BID MEMO 01

<u>Saints - Cafeteria & Viewing Area</u>

REVISION #01

New Orleans Saints Viewing Area and Cafeteria Expansion 5800 Airline Drive Metairie, Louisiana 70003

DRAWN BY I WDG A2.03

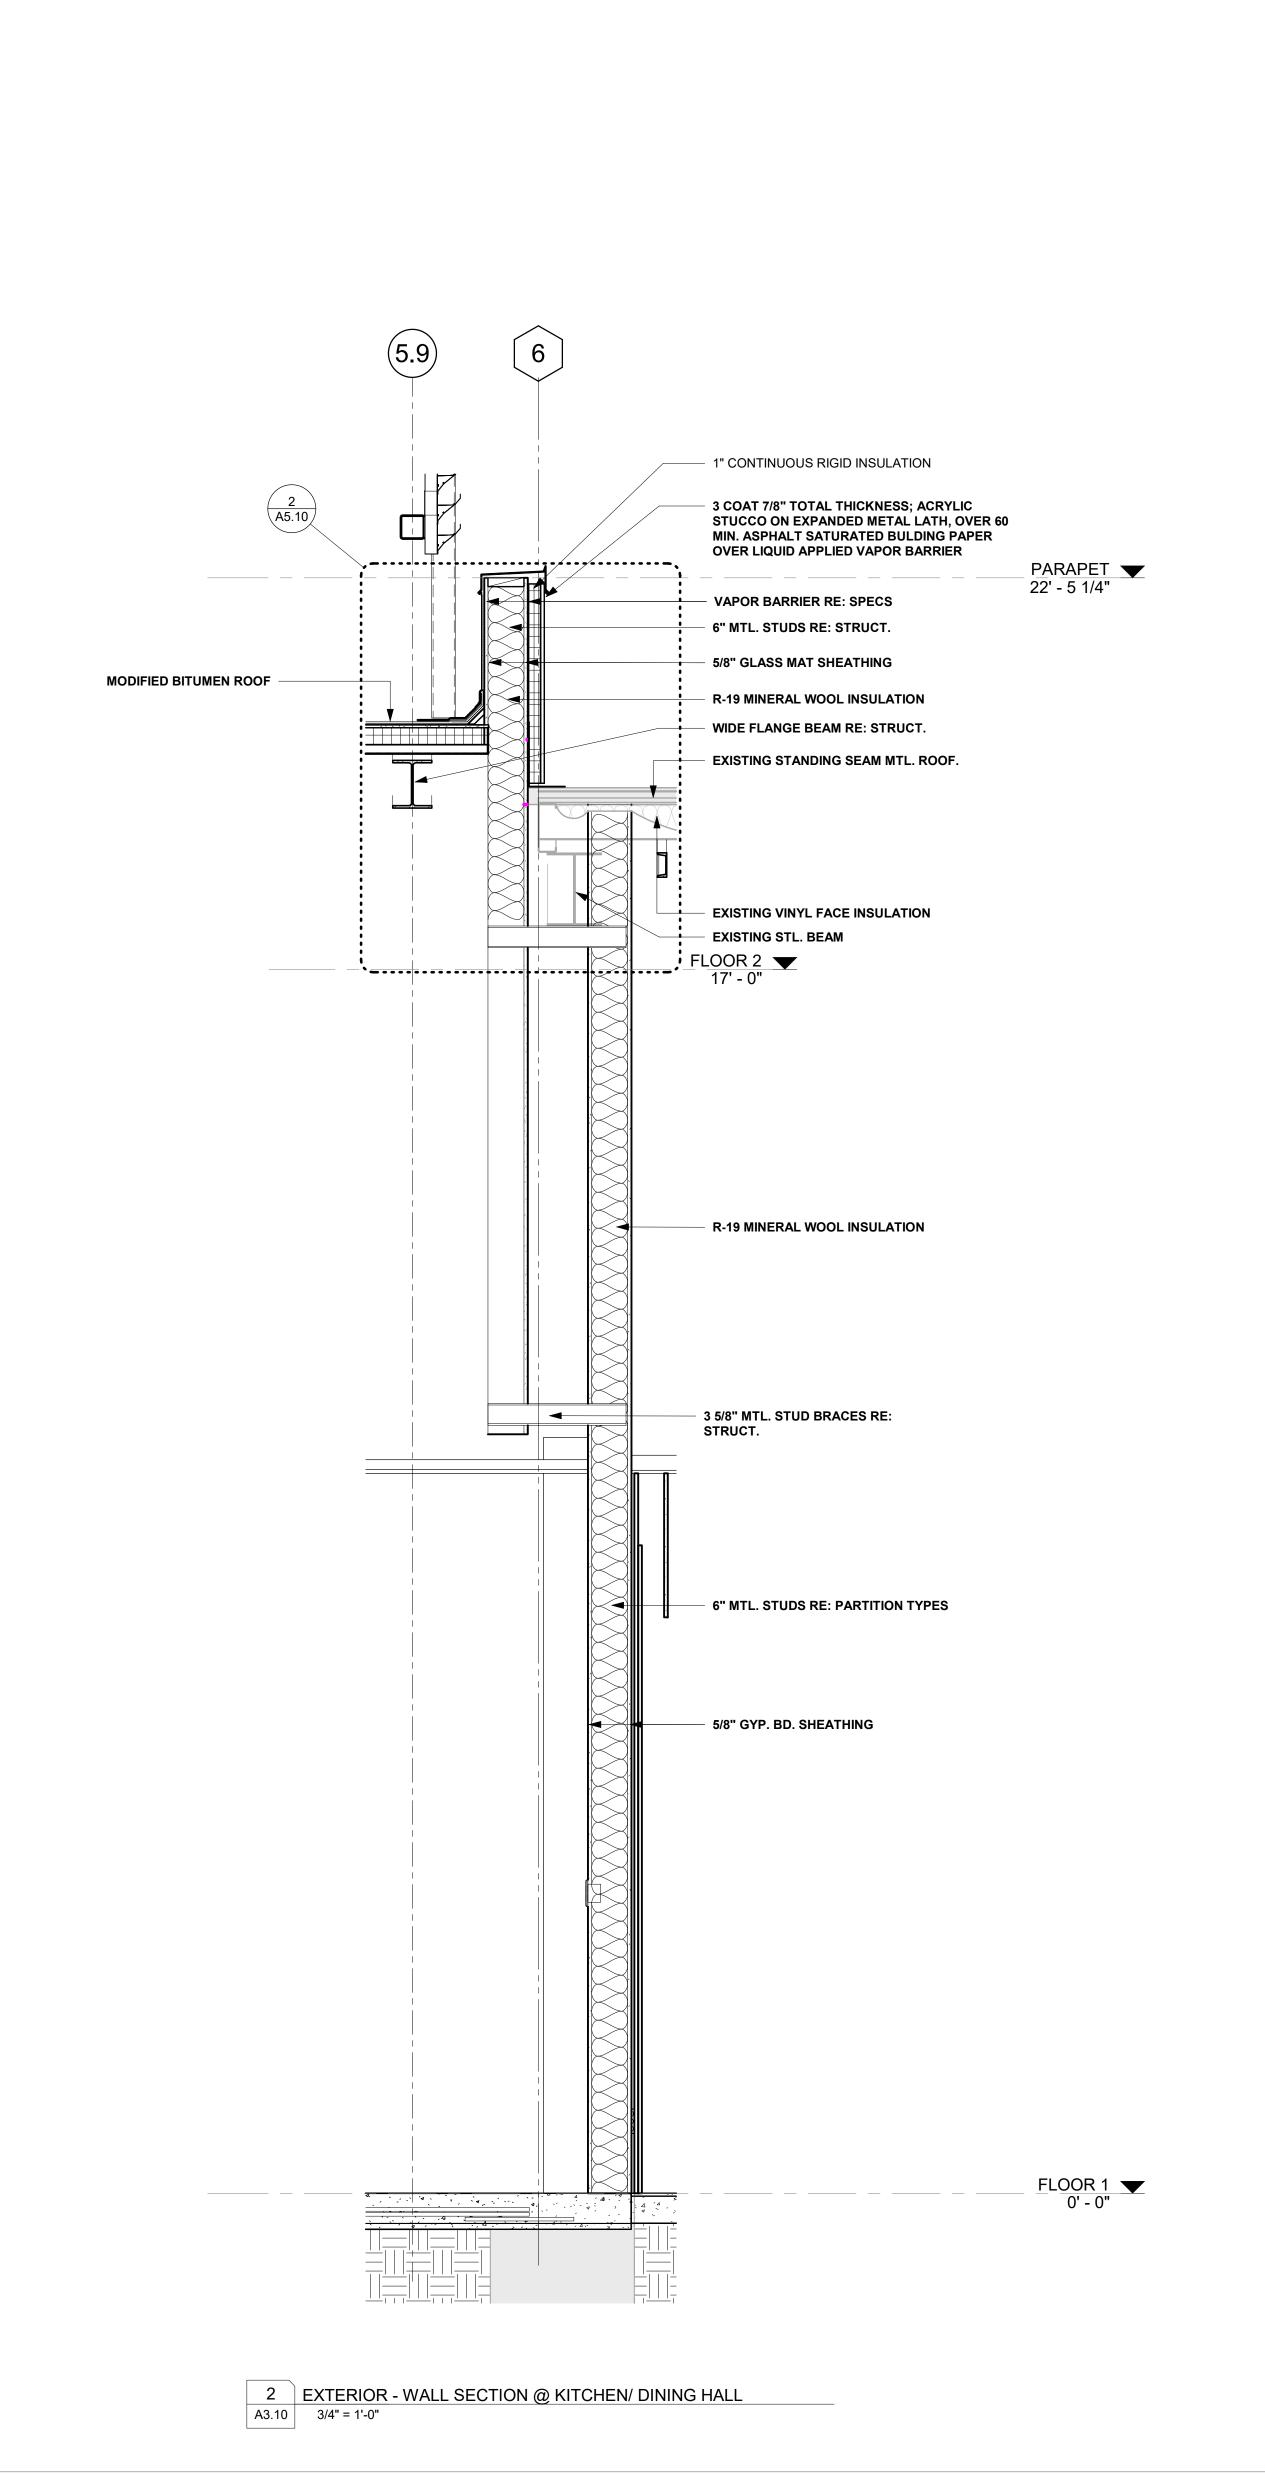
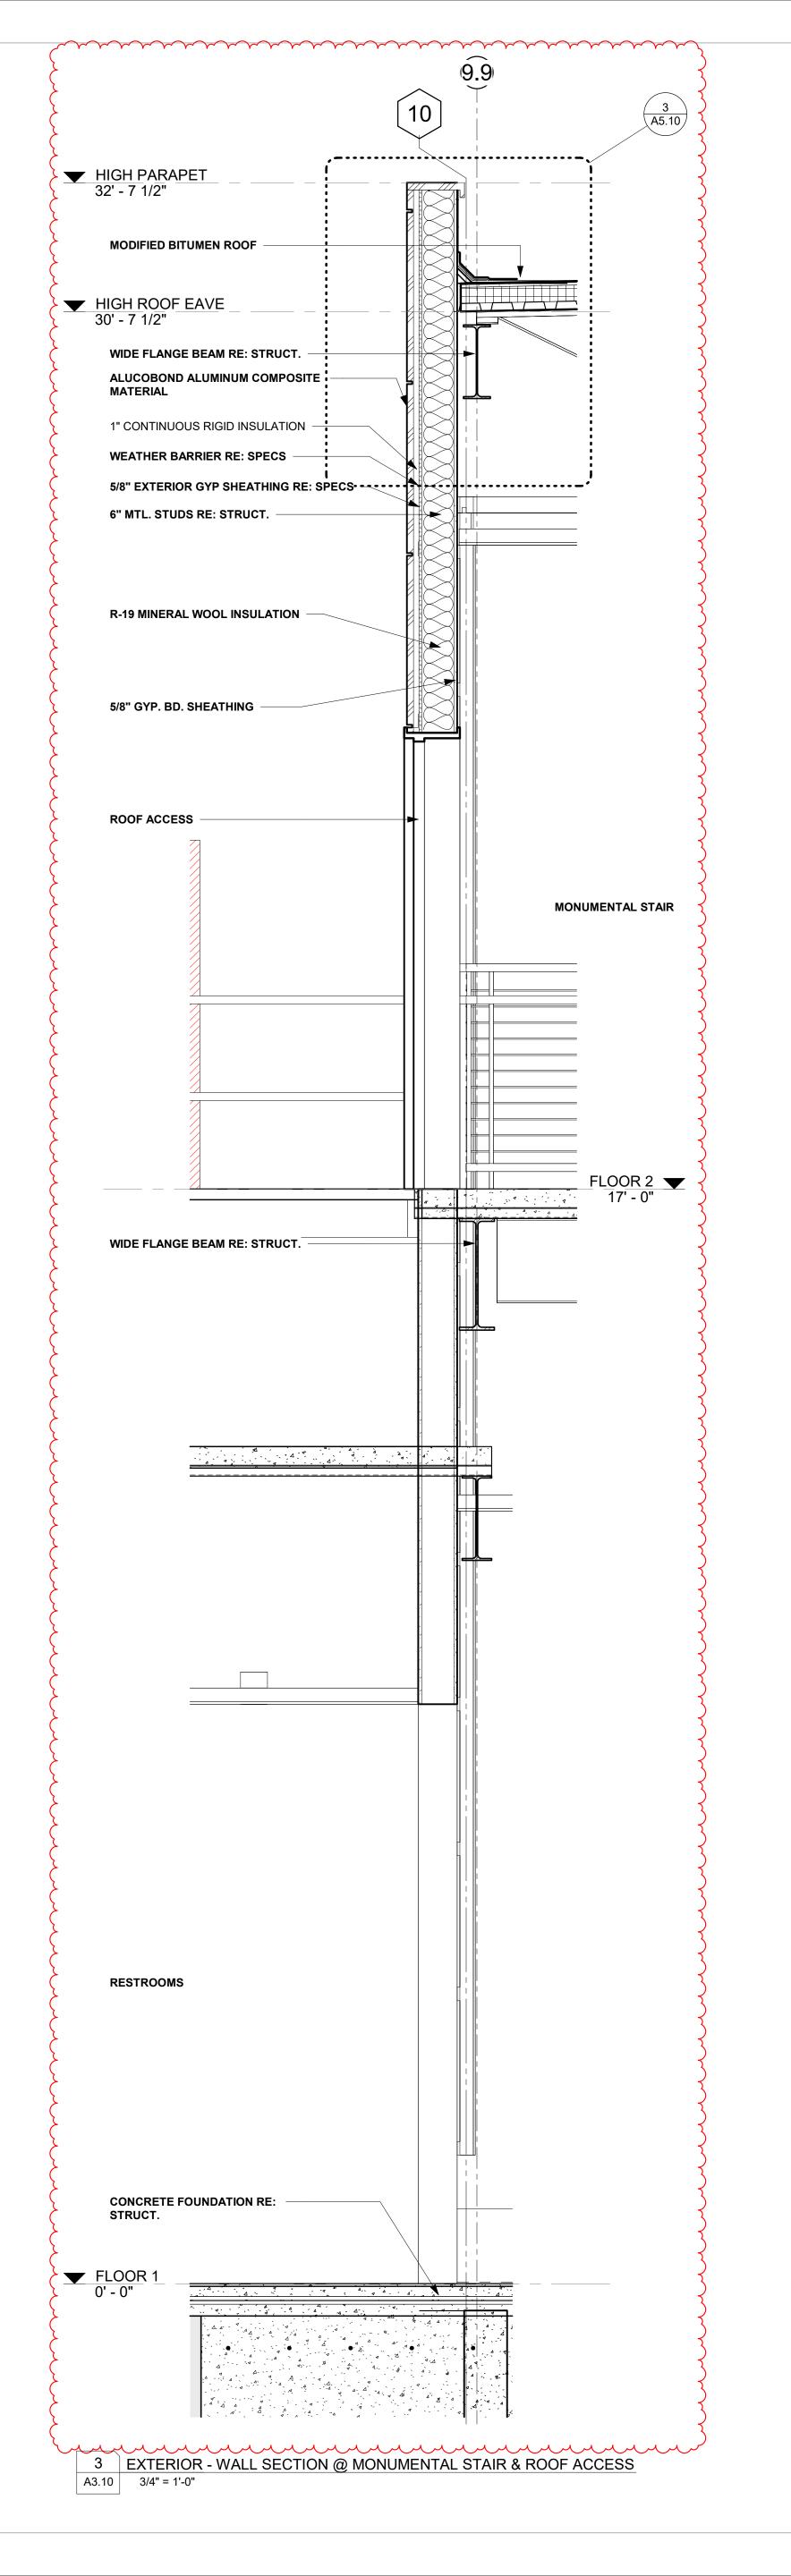
- Mechanical screen updated with new section A2.00 & A2.01
- Outdoor seating area detailed with wood planks for bench with revised chamfered corners at planters - A2.03

DRAWN BY | WDG A3.10

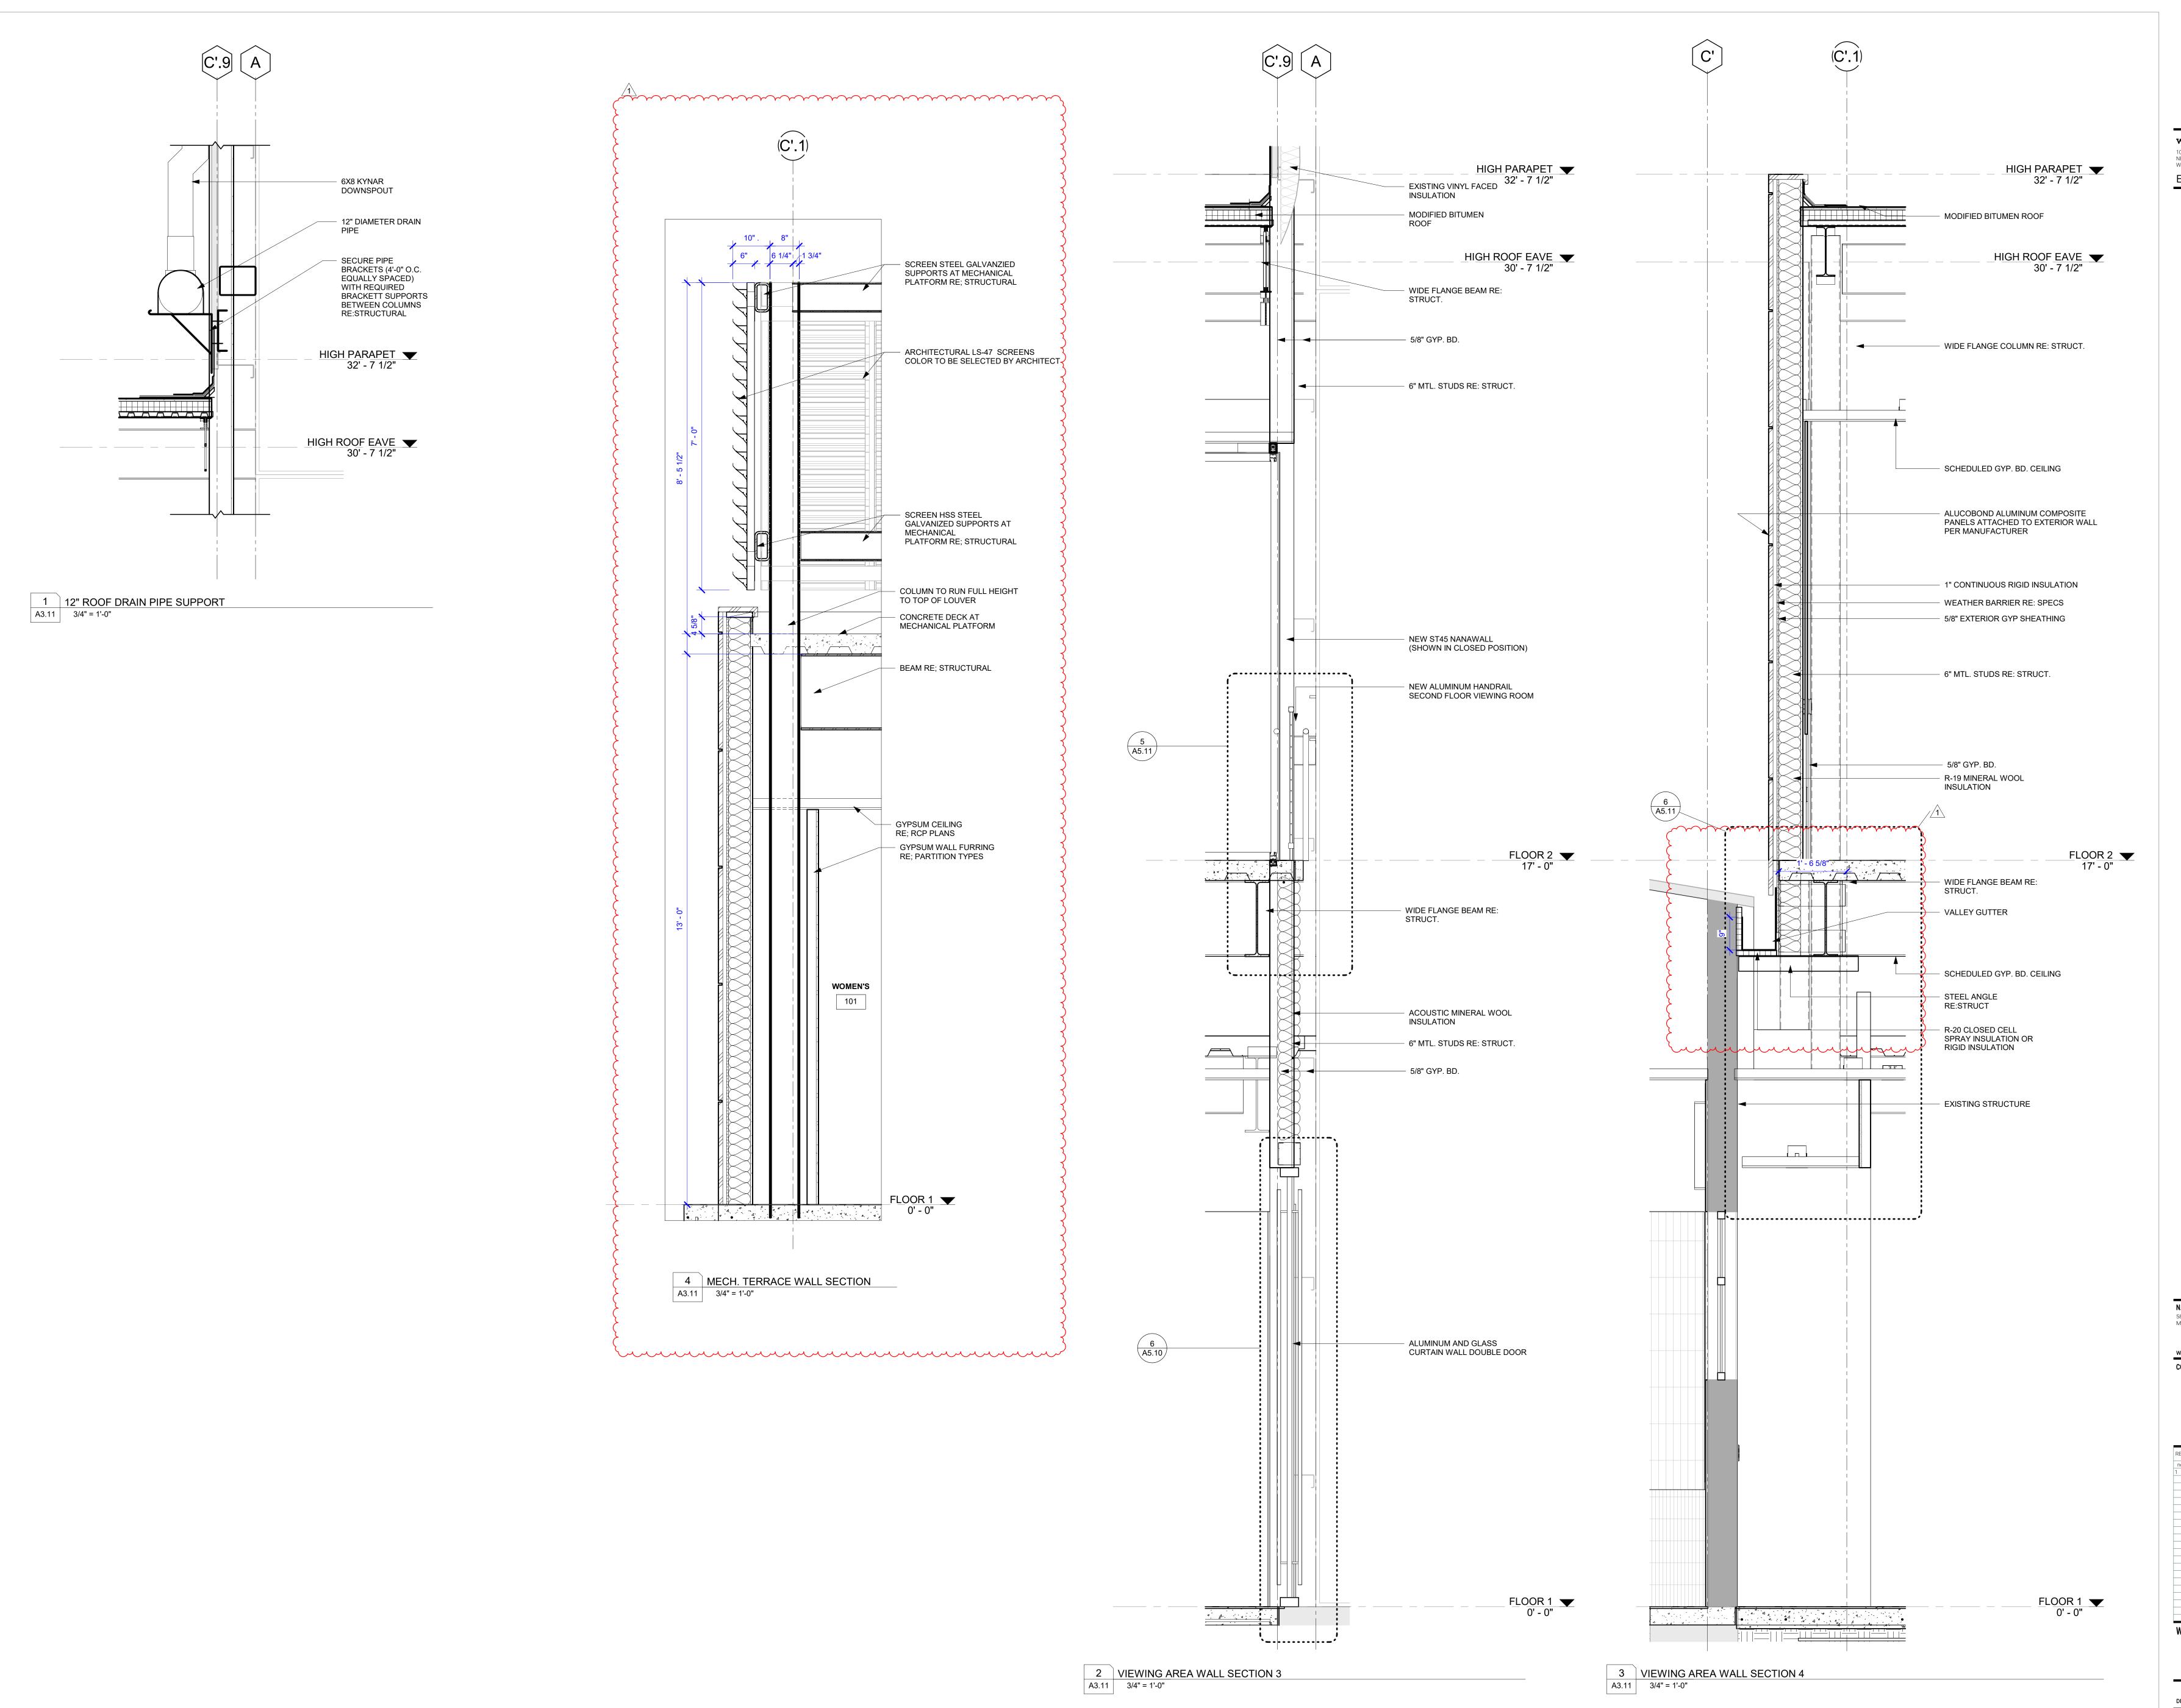
- Revised structural post attaching to roof joist over kitchen A3.00
- 7'-0" tall louver screen detailed above kitchen along with adjust ACM panels A3.10
